Re: Addendum No. 2 to the South Orange County Reliability Enhancement Project Minor Project Refinement No. 1.

ATTACHMENT A
MPR-1 Addendum No. 2 Figure

SOCRE PROJECT
MPR-1 FIGURE 1 ADDENDUM 2
SAN JUAN CAPISTRANO SUBSTATION
San Juan Capistrano
Orange County, CA

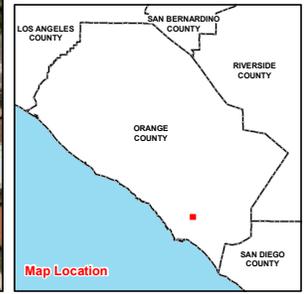
SDG&E respectfully requests approval of MPR-1 Addendum No. 2 to allow vegetation on the east side of the Substation to be removed in order to facilitate security fence replacement by March 26, 2021. Should you have any questions or need additional information, please do not hesitate to contact me at (858) 654-8211 or by email at rquasarano@sdge.com.
